## Primary Or Secondary?

### **The Glitch**

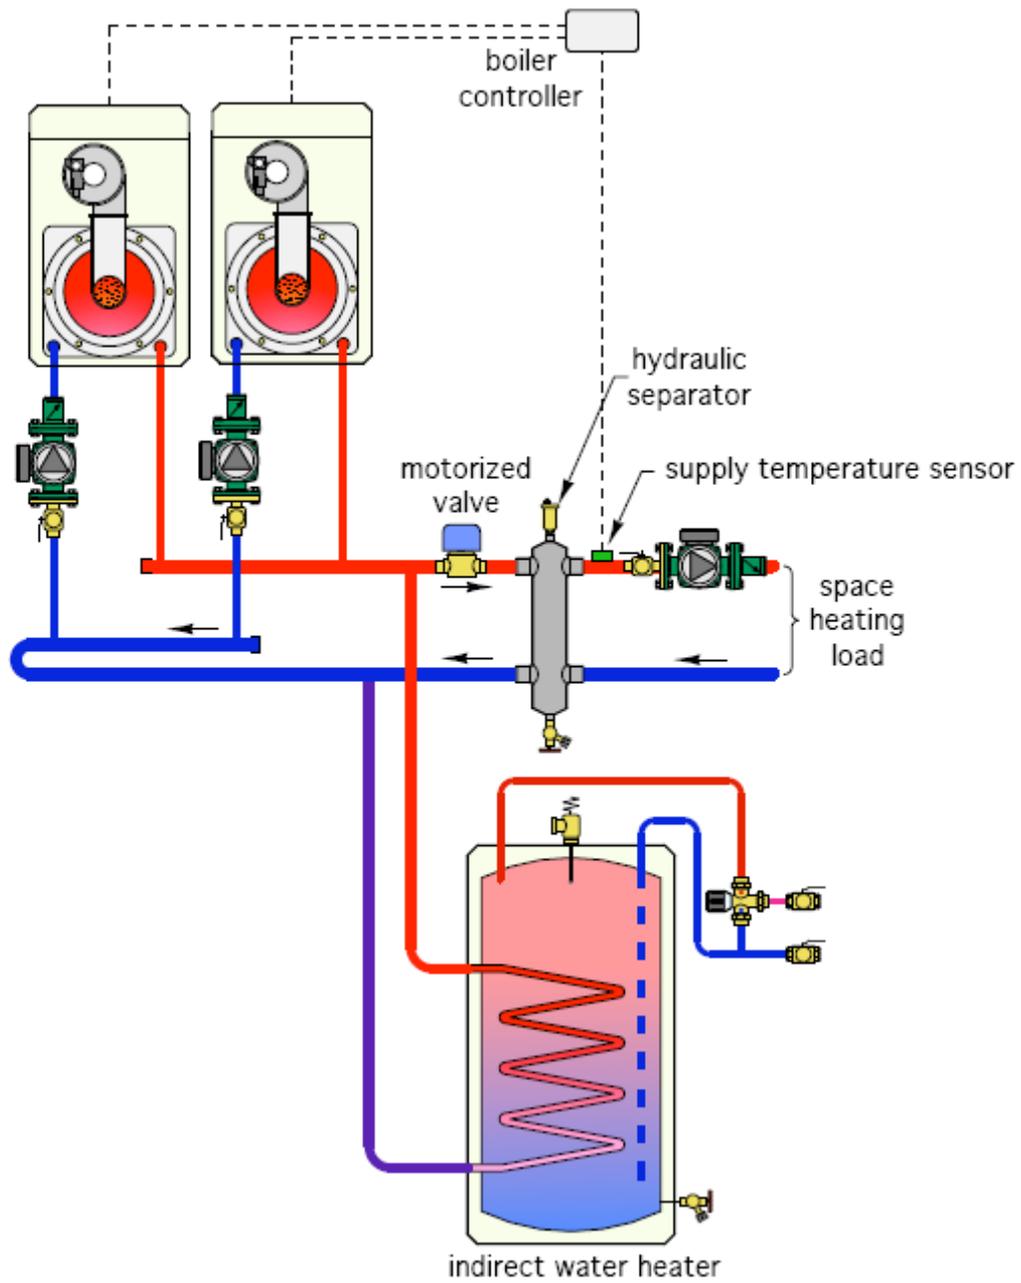
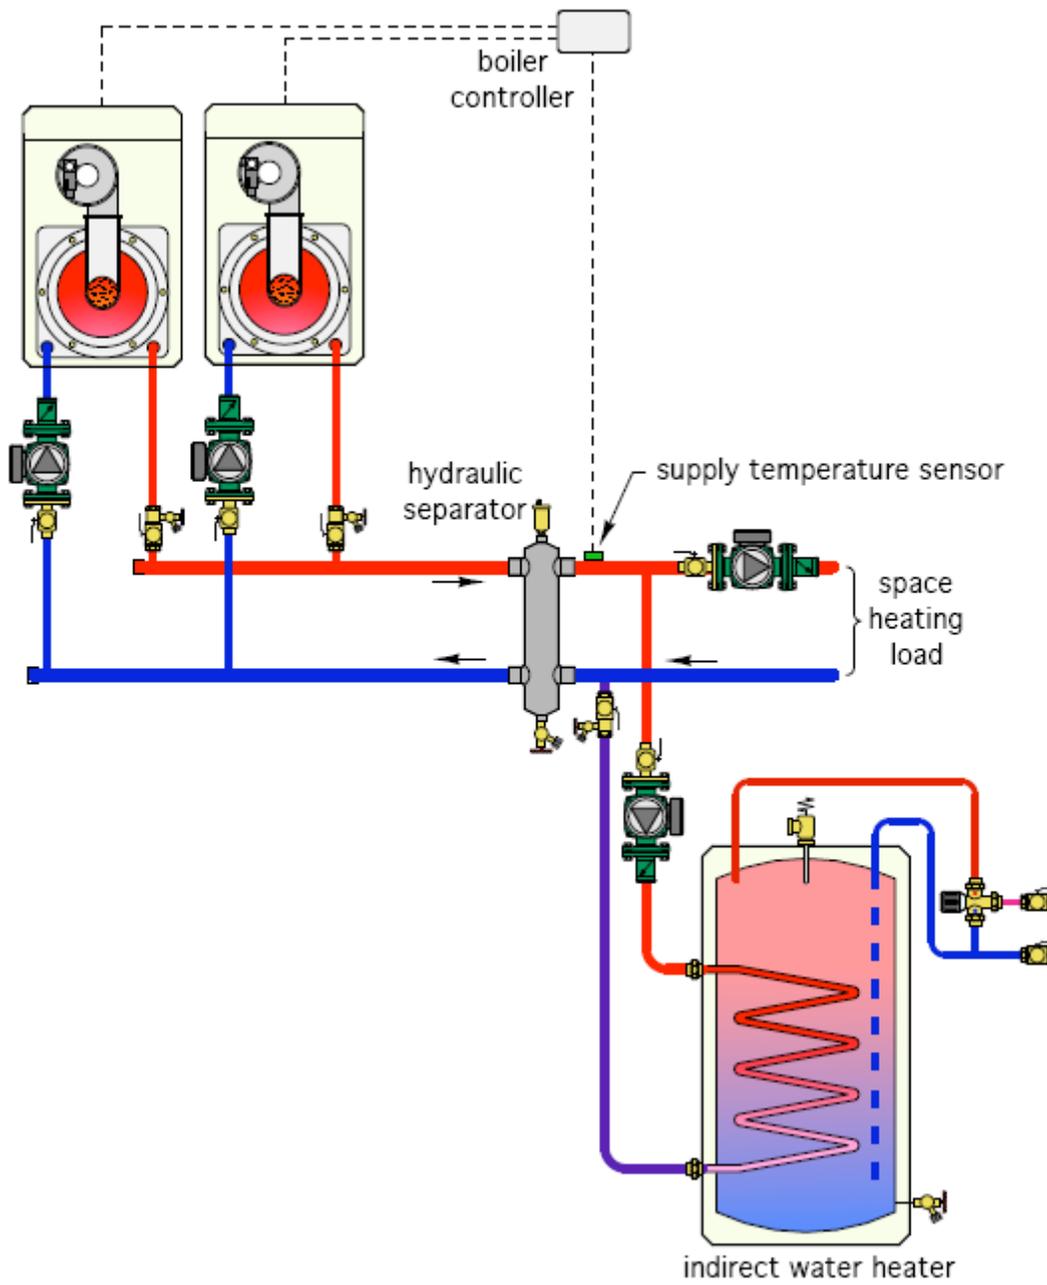
*Overview:* A designer needs to connect an indirect water heater to a multiple-boiler system. He selects a hydraulic separator for the project and connects the piping of the indirect water heater on the same side as the boilers. He also specifies a motorized valve as shown in the schematic. This valve will close during the domestic water heating cycle so that one or both of the boiler circulators can drive flow through the indirect water heater.

One problem with the original design is that the supply temperature sensor for the multiple boiler controller is installed on the outlet side of the hydraulic separator. Most boiler controllers only have a single supply temperature sensor that has to provide feedback to the controller in both the space heating and domestic water heating modes. The sensor cannot provide accurate feedback without flow passing through the piping to which it is attached (as would be the case with the original design).

The cost of a large motorized valve is probably as much if not more than a separate circulator for the indirect water heater. The latter also ensures good flow through the tank's heat exchanger regardless of flow through the boiler(s).

Maintaining flow through the hydraulic separator in both operating modes also allows the air and dirt separating functions of the hydraulic separator to remain in effect. Heat loss from the hydraulic separator is reduced during both operating modes by its insulating shell û this shell is an absolute must for any hydraulic separator.

The reverse return piping on the boilers, while not necessarily an error, is usually not necessary provided the header is sized for a very low pressure drop. This is almost always the case when the parallel piping paths connected to the headers each contains a circulator.

Finally, purging valves, an expansion tank, and a make-up water assembly have been added to the sub-circuits in the fix drawing.
